VILLAGE OF GERMANTOWN
N112 W17001 MEQUON ROAD, GERMANTOWN, WI 53022

MEETING:	PLAN COMMISSION
DATE AND TIME:	MONDAY, June 13, 2022 6:30 p.m.
LOCATION:	Germantown Village Hall Board Room, N112 W17001 Mequon Road

SITE PLAN REVIEW

Mike Faber, agent for Capstone Quadrangle Development Company and CQ WI 2021 LLC, property owner, is requesting approval of revised site development plans (grading and landscaping) for the 203,580 sqft industrial building located within the Capstone 41 Business Park and Holy Hill Road Gateway District.

THESE PLANS AND DESIGN ARE COPYRIGHT PROTECTED AND MAY NOT BE USED IN WHOLE OR IN PART WITHOUT THE WRITTEN CONSENT OF PINNACLE ENGINEERING GROUP, LLC. REVISION: DUB REVISION: JSA REVISION: LSA

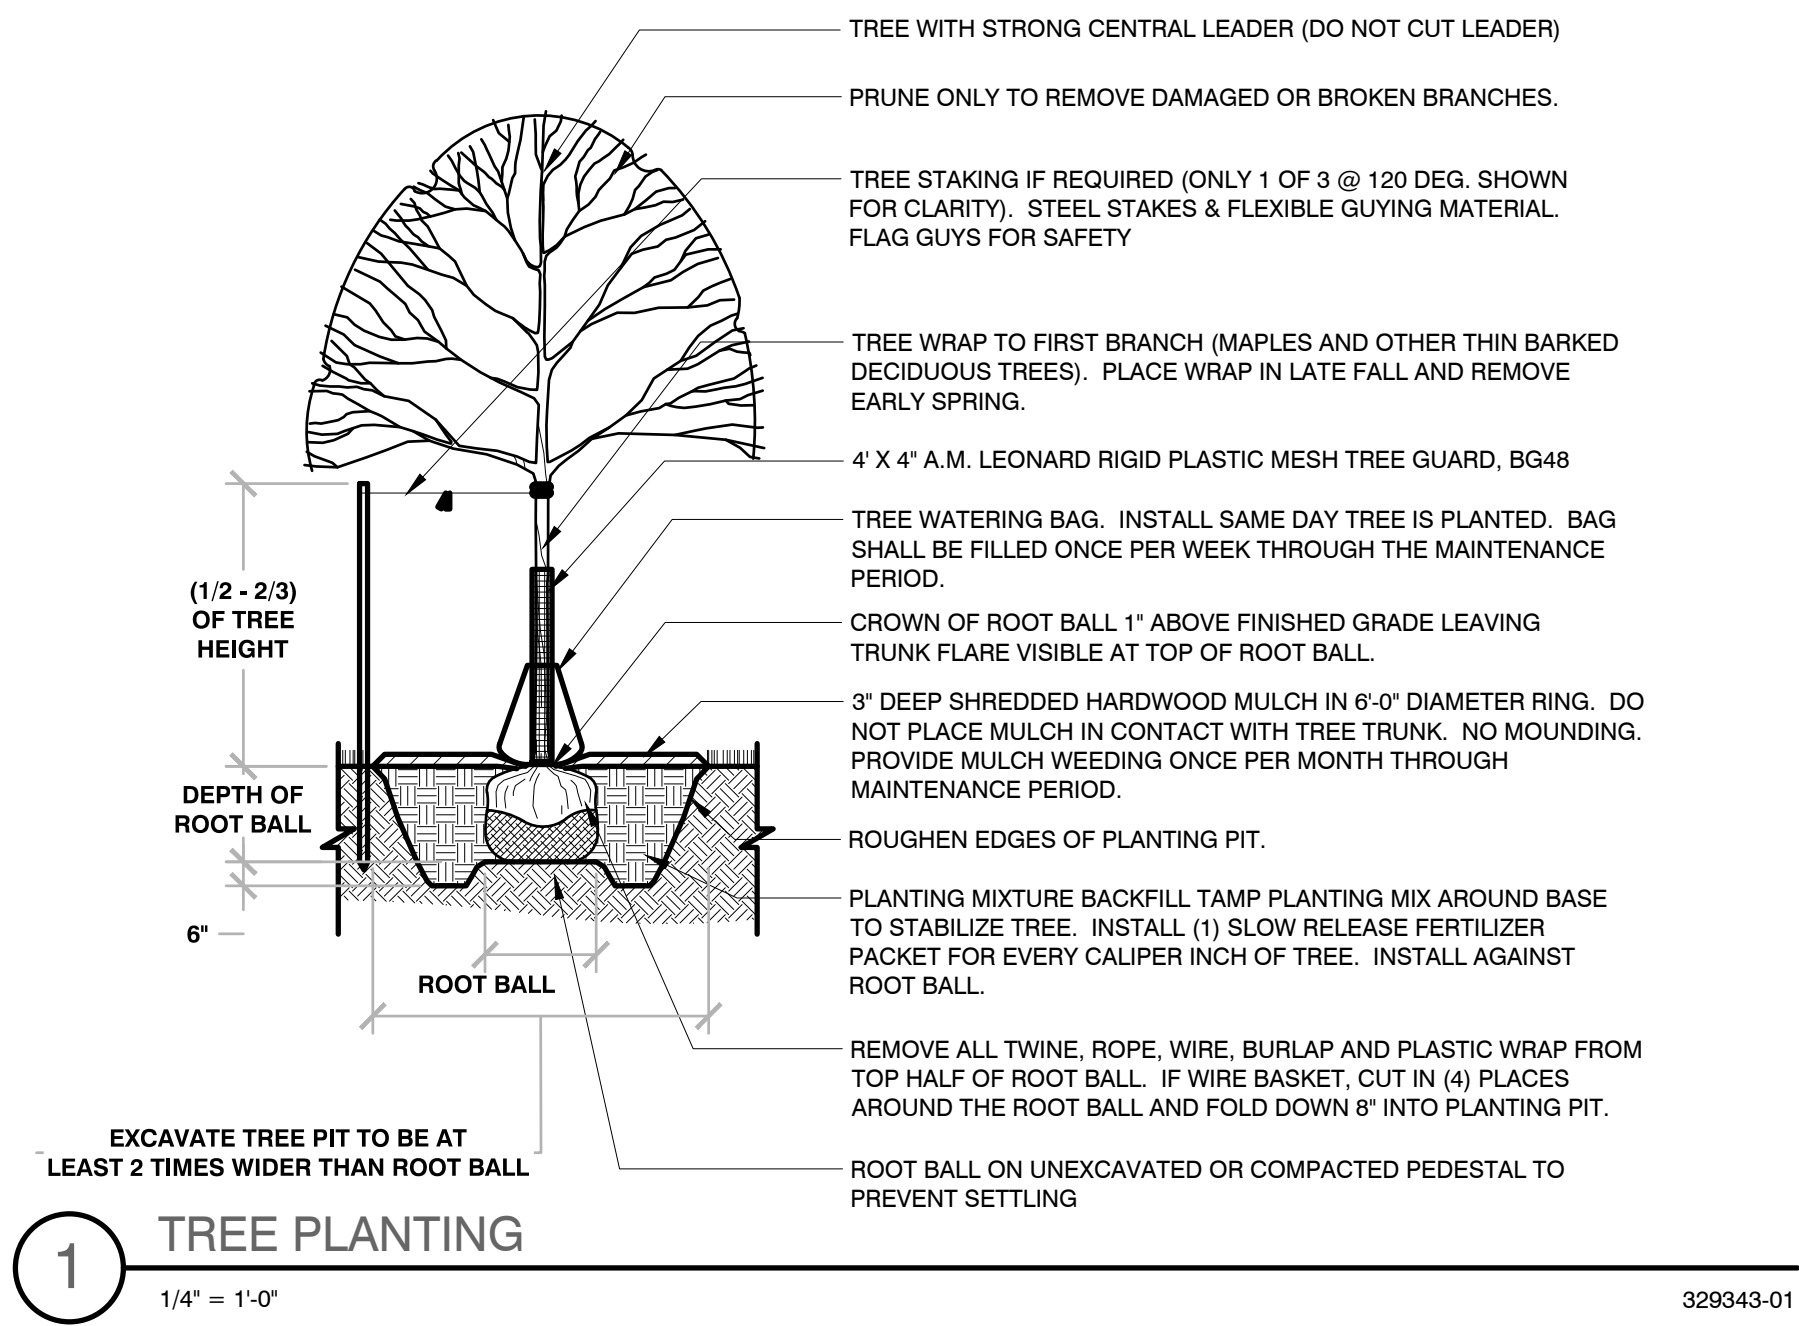
The Plan Commission determination on August 9, 2021 also required that we supplement the landscape material quantities along our Holy Hill Road frontage on the berm, in order to help better screen the truck court, and also asked if it was possible to provide a “drive-by” video rendering to help the Village assess what the landscape density would be (at both installation and at a more mature size at the 5-6 year point). We have modified the landscape plantings by adding good quantities, and we think the drawings, renderings, and videos convey that the truck court is suitably screened. Due to the grades of Holy Hill Road relative to the grade of the truck court, even prior to raising the berms, the most important visual range is the 0’ – 10’ above the berm height. Thus the most beneficial of the added plantings are in that “relevant zone”.

Our landscape architect (Dale Bunderson of Pinnacle Engineering Group) advises that this planting density is as close together as he would recommend for normal plant health. It would be possible to pack more in, but Dale states that is generally frowned upon, because the trees grow into each other, competing for sunlight and moisture / nutrients, and in the long run would not be as healthy nor live as long as trees with proper spacing for optimal health.

As shown in the revised plans, renderings and “drive-by” videos, additional plantings have been added along the west side of the truck parking/staging area, and, along to the north elevation abutting Holy Hill Road with modifications to the berm height and undulation. “Drive-by” videos along Holy Hill road at two different time intervals, at the time of planting g and at 5 years growth, have been prepared as requested by the Plan Commission.

GRADING PLAN
SCREENING BERM REVISIONS

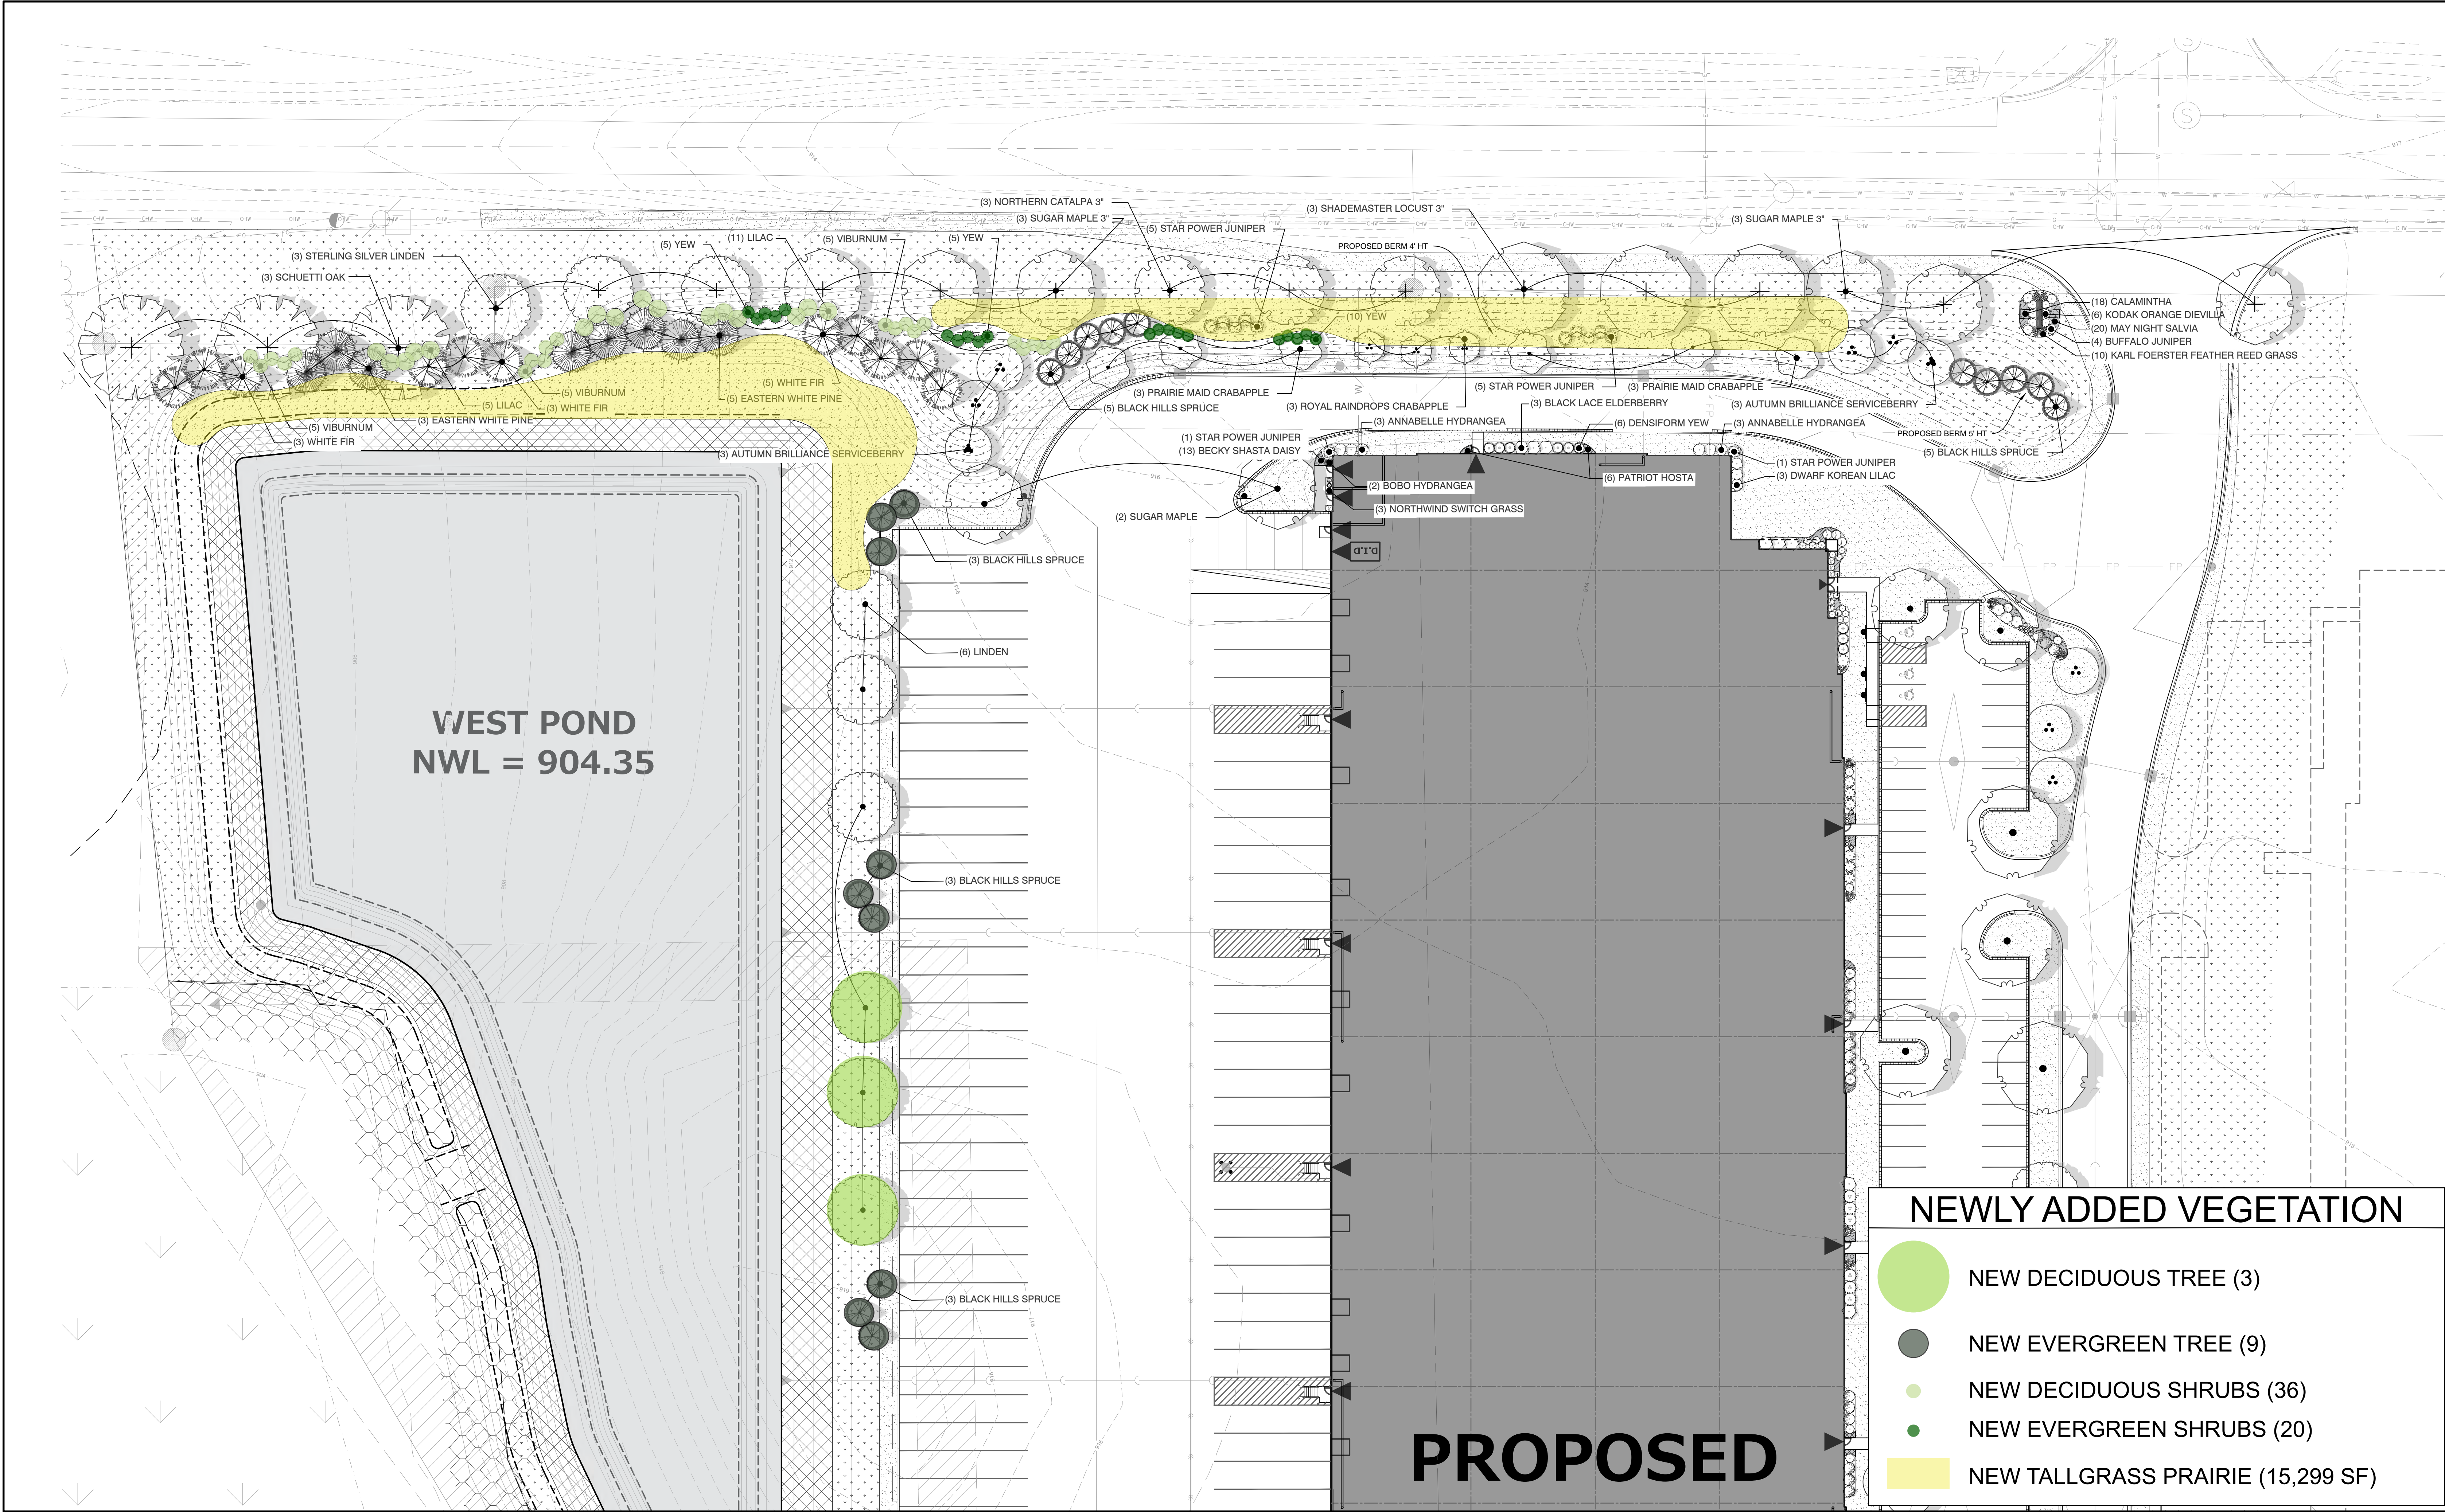
10. The amount of landscaping and berm height & design for the area along the north elevation of the building abutting Holy Hill Road shall be supplemented with additional berming and landscaping. Additional landscaping including a mix of evergreen and deciduous trees shall be installed along the west side of the truck parking/staging area west of the building to provide a better (future) visual screen of the truck activity. A revised landscape & berm plan shall be prepared and submitted to the Plan Commission for review and approval prior to issuance of an initial occupancy permit for the 203,580 sqft building.

At the time the plans were approved last August, staff reported that there is insufficient area between the north side of the building and the Holy Hill Road property line within which to install any significant berm and/or landscaping. The grading plan indicated a straight and continuous berm (vs. undulating and serpentine) approximately 400' in length and a height of up to 918' will be installed along the north side of the building. Two small areas at either end have an increased height up to 920'. Staff indicated that with a finished floor elevation of 915' for the building and a tentative re-constructed road elevation of approximately 915 feet, the proposed berm would have had minimal impact (a 2'-3' net increase in height). Consequently, staff recommended that the amount of landscaping and berm height needs to be supplemented with additional berm height and plantings since the proposal is to install “no mow” turf on the berm so the grade of those areas could be steeper allowing for more height and variability of the berm.

We are happy to increase the height/size of the berm. We are severely pinched between our property line and the critical drive lane around the building, so we need to increase the slopes in a few spots to accomplish that. I have no problem with steeper slopes where mowing is not applicable - like this situation – please refer to the proposed revised berm grading. On this drawing exhibit, the top panel has the current grading plan with the blue proposed revisions overlaid, so you can easily identify the changes. The bottom panel is the "clean" version of just the revised grades. As you will note, the height has been raised in several places fairly significantly but undulating both vertically and horizontally to create a more natural look within the space we have to work. We think higher than this is not feasible since we cannot change the grades out in the Right-of-Way, and the slopes would get too steep. But these revisions do raise the height measurably – as much as 4 and 5 feet higher – and also create some nice undulations.

Staff recommends approval of the revised berm height and additional plantings shown in the plans and renderings.

1. This approval is subject to all the conditions and requirements set forth herein and adopted by the Plan Commission. Approval is granted for the following revised plans:
 - a. *Grading Plan Sheet EX-1 (Screening Berm Revisions) dated June 1, 2022;*
 - b. *Landscaping Plan Sheets L-1 to L-5 dated September 20, 2021;*
2. All landscaping, screening, grading, and paving improvements shown on the approved site plans shall be installed as proposed prior to issuance of an occupancy permit unless a cash bond or letter of credit in an amount equal to 120 percent of the estimated installation and material costs reviewed and approved by the Village is submitted to the Village as necessary to ensure that installation of the proposed features and improvements will be completed within one (1) year after issuance of the occupancy permit for the shell building.

SITE UTILITY PLAN

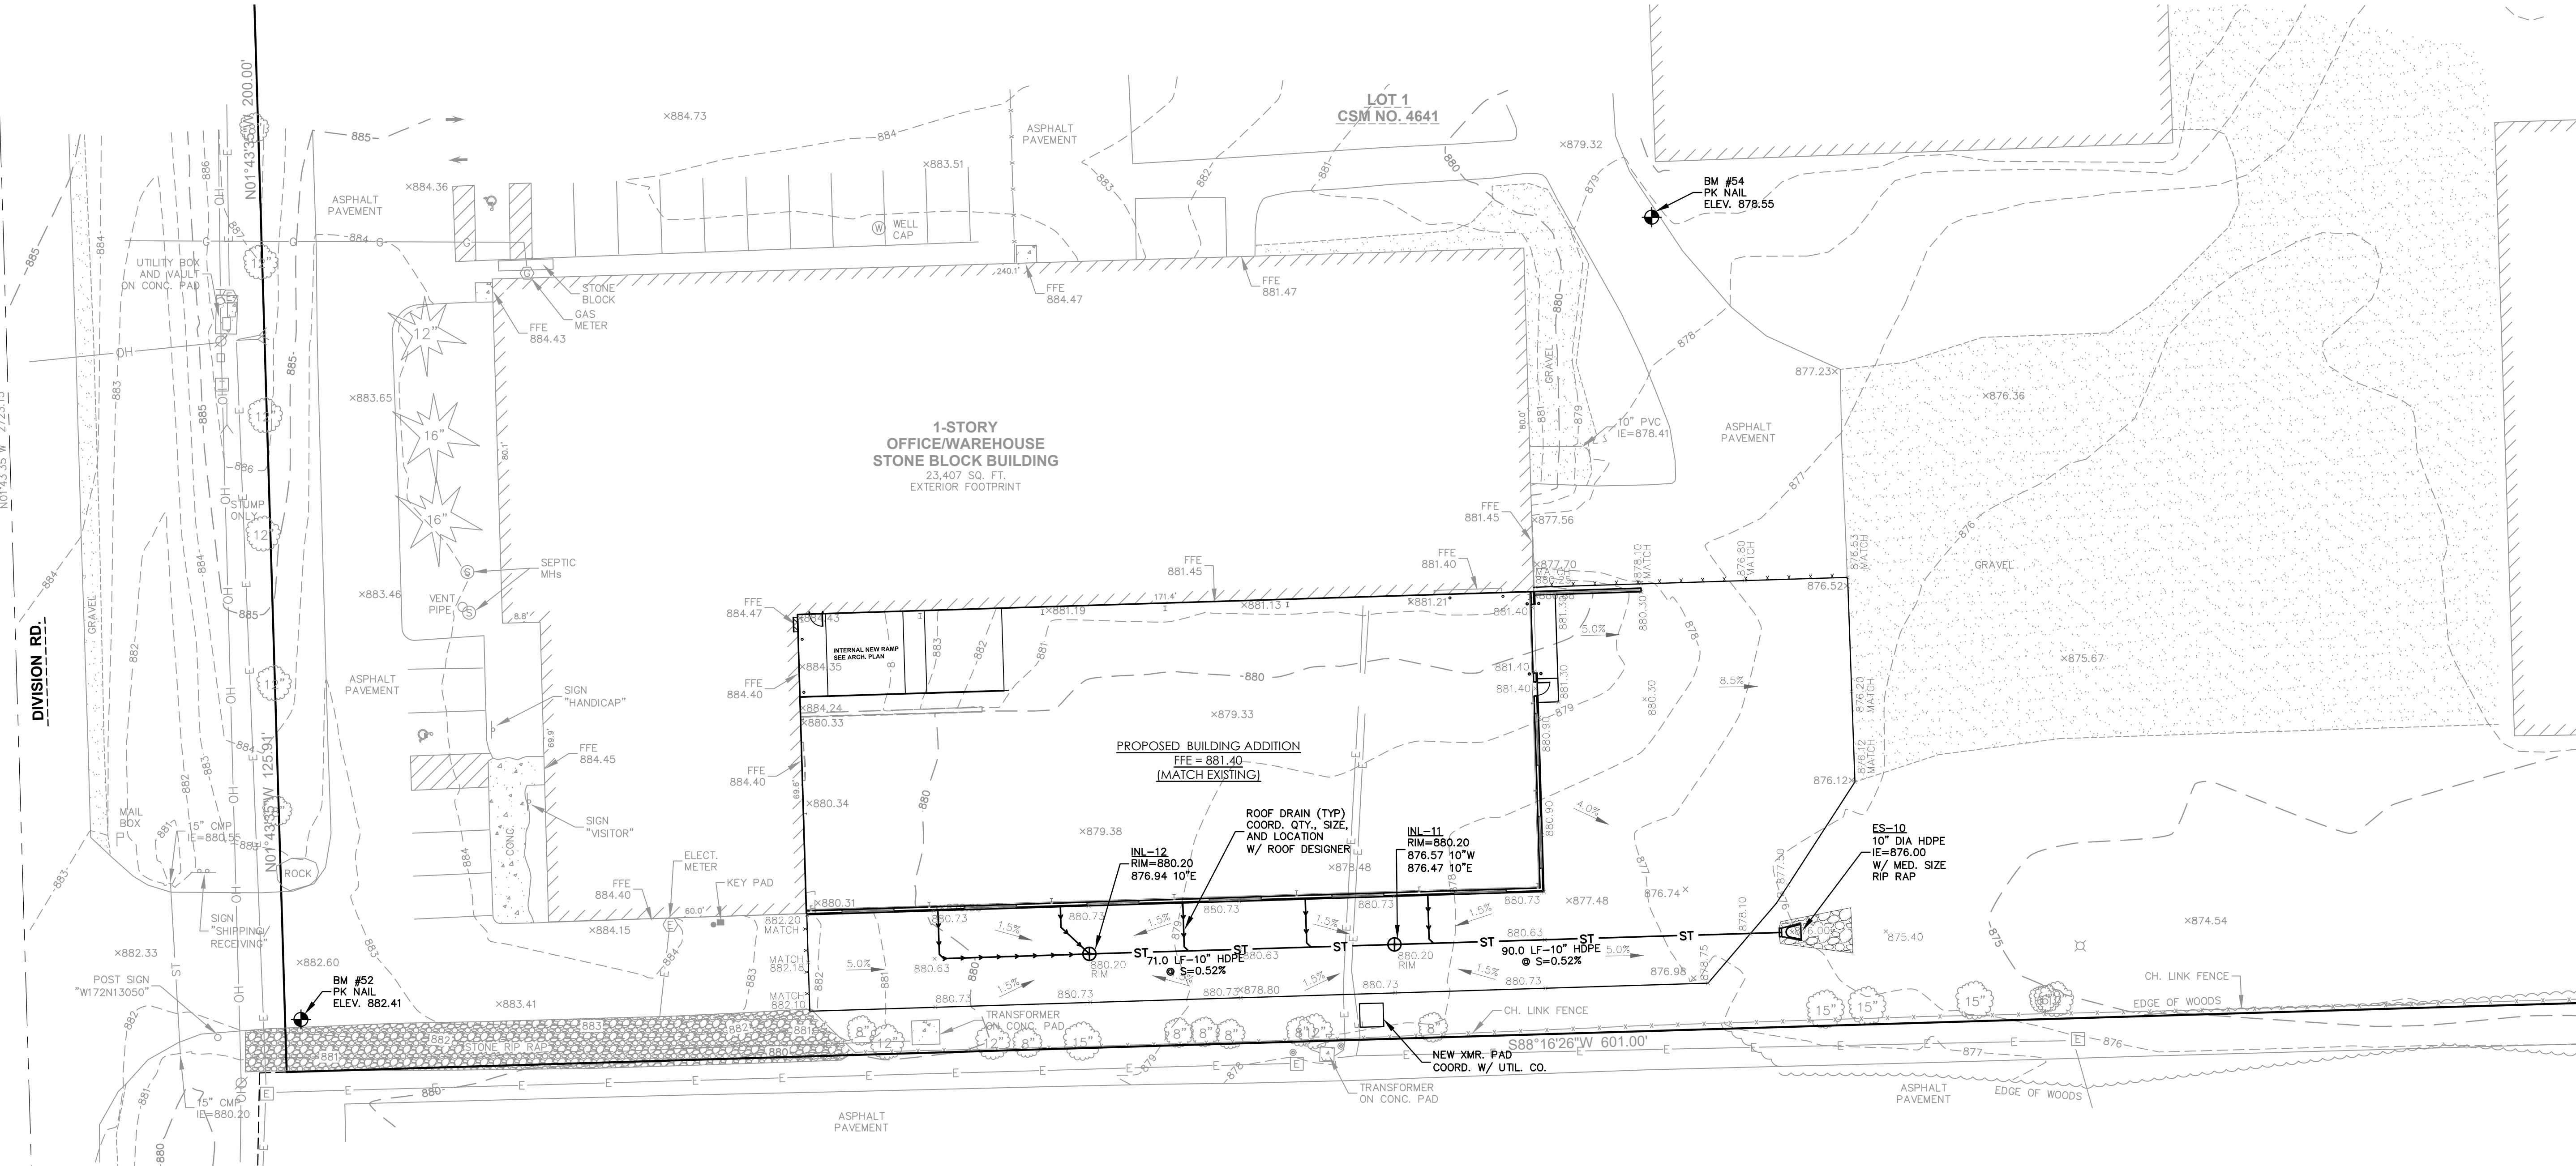
6. Please provide storm sewer calculations for new storm sewer.
7. Provide size, slope and connection type for the roof drain leaders.
